Percolation Test Report; 14510 Triadelphia Mill Road

**RE:** Perc Cert Plan  
Kenneth Carpenter Jr.  
14510 Triadelphia Mill Road

The submitted Percolation Certification Plan has been reviewed by the Well and Septic Program and will not be approved at this time. Issues cited for editing follow:

PERCOLATION CERTIFICATION PLAN  
PROPERTY OF  
KENNETH R. CARPENTER, JR.  
LOT 1 PARCEL 11  
#14510 TRIADELPHIA MILL ROAD  
TAX ACCOUNT #05-370523  
TAX MAP 27 GRID 17 PARCEL 96  
5TH ELECTION DISTRICT HOWARD COUNTY, MD.  
DATE: 7/2016 SCALE: 1" = 100'  
REVISED: 11/2019

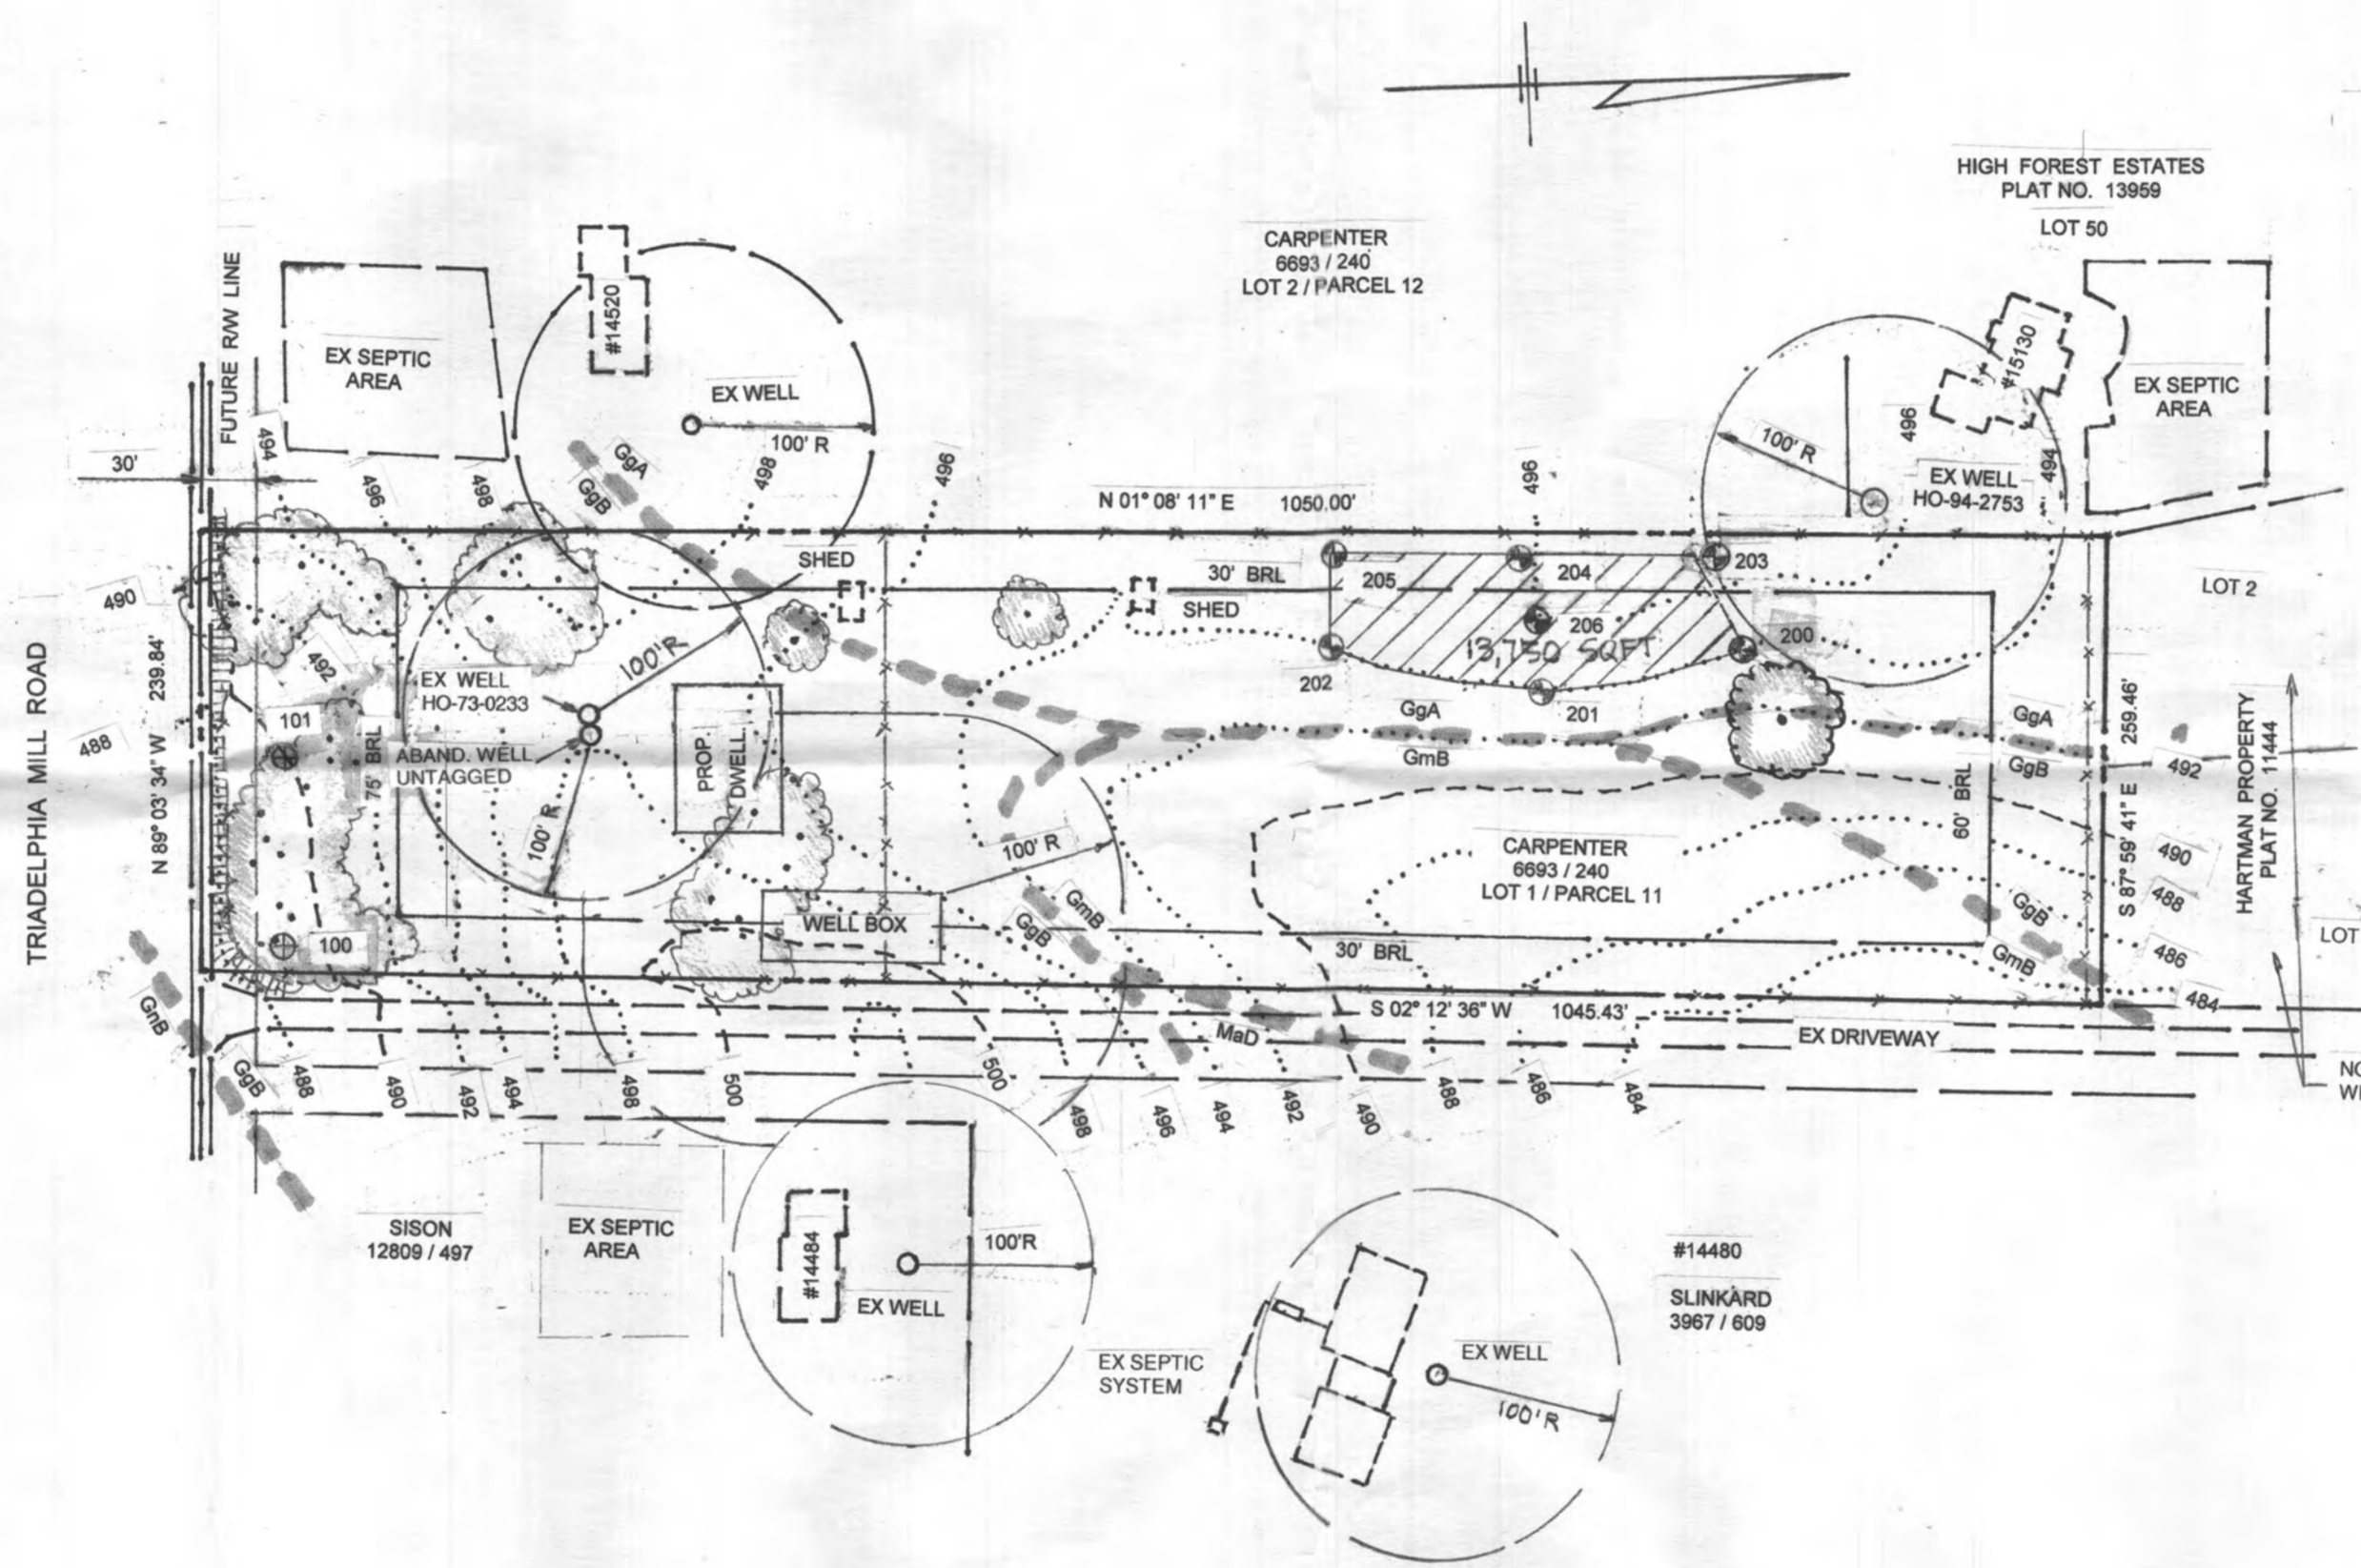
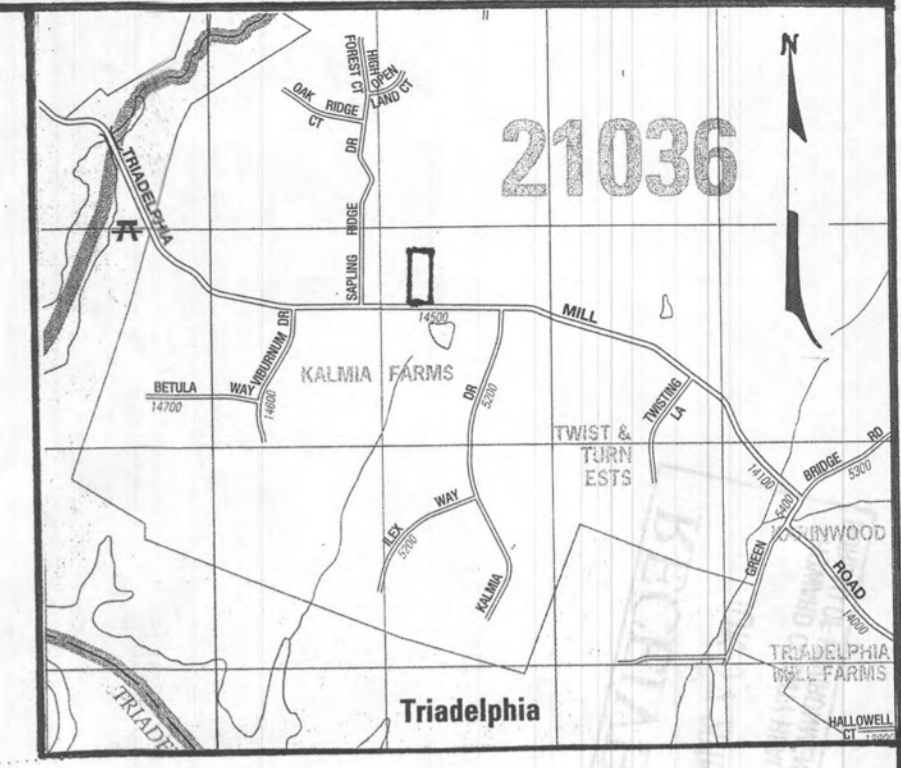
In general, the well radius around the well box and the wells on the neighboring lots aren't 100 % accurate. Also, I don't think you need to show a radius line for the abandoned well. Please check all of them for accuracy.

- 1.) Correct 100 foot well radius on the existing well. It isn't quite 100 feet all the way around it.
- 2.) Add amount of square footage to the sewage disposal area.
- 3.) Change legend symbol description for *perc test location/clay* to *perc test location/fail*.

PERCOLATION TEST APPLICATION PLAN  
PROPERTY OF  
KENNETH R. CARPENTER, JR.  
LOT 1 PARCEL 11  
#14510 TRIADELPHIA MILL ROAD  
TAX ACCOUNT #05 - 370523  
TAX MAP 27 GRID 17 PARCEL 98  
5TH ELECTION DISTRICT HOWARD COUNTY, MD.  
DATE: 5/2016      SCALE: 1" = 100'

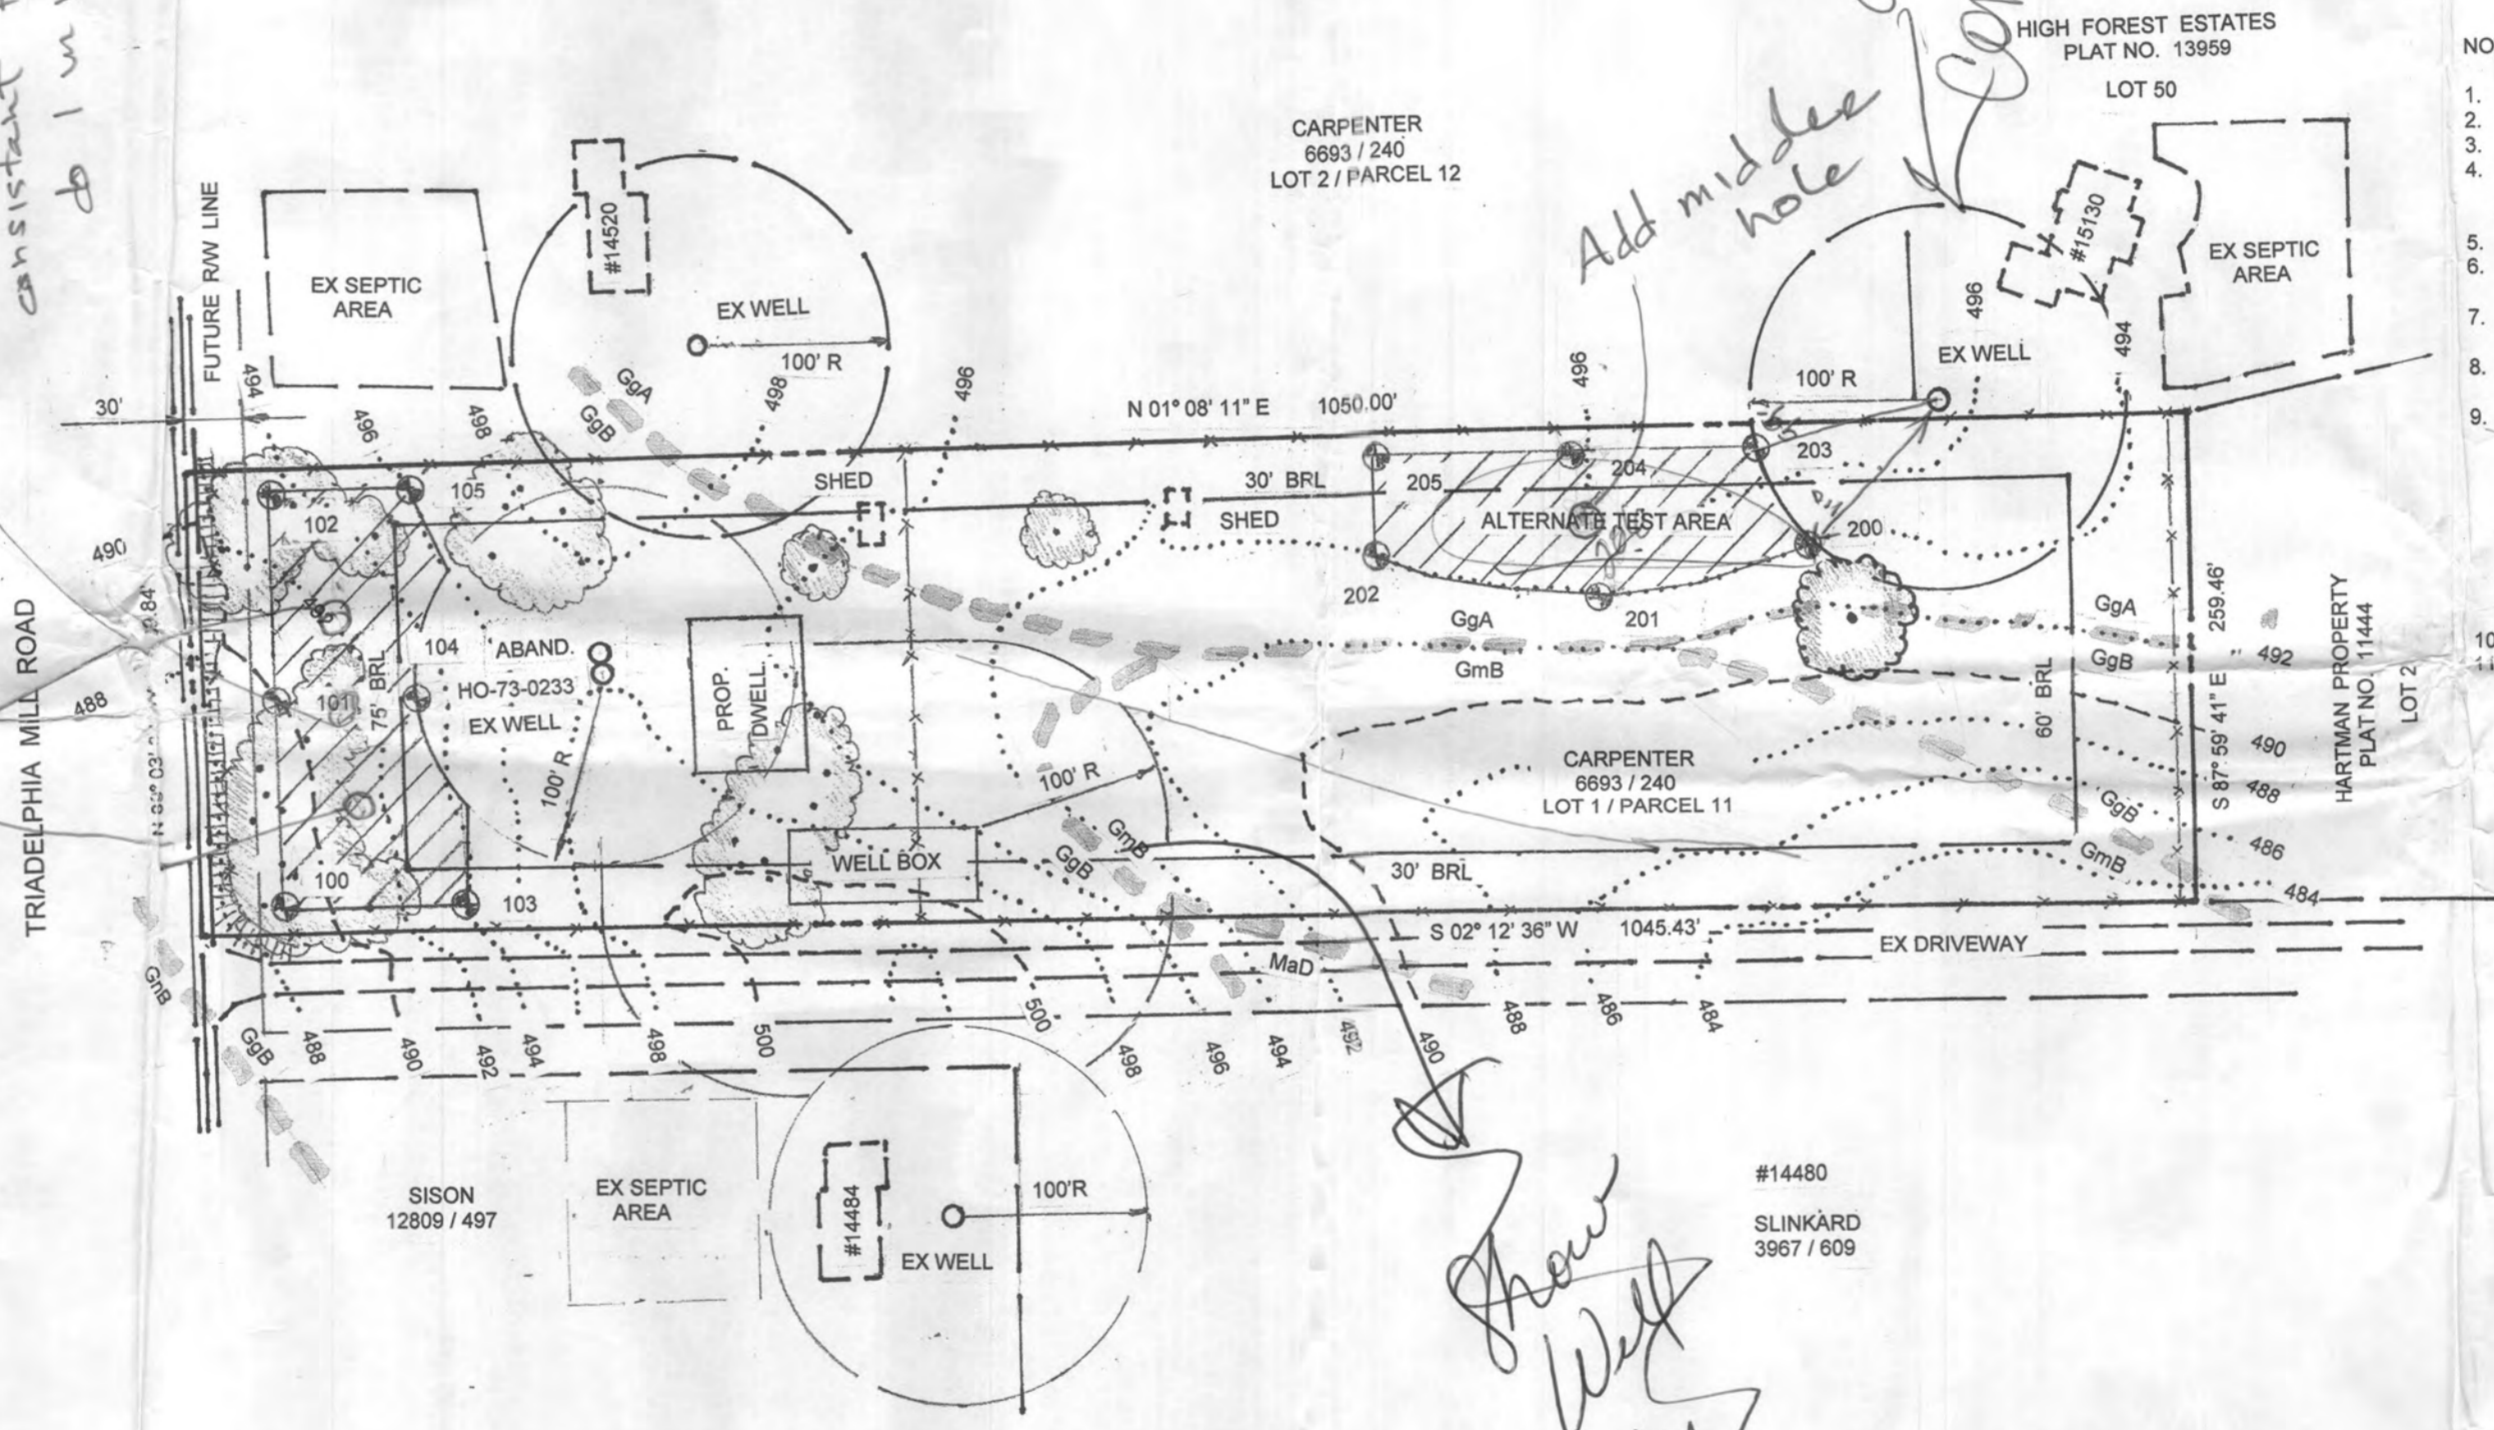
*If hole arent consistent then add middle one - If (4) corners are consistent then add middle do 1 in middle.*

*Add middle hole area of concern*

*Show Well for*
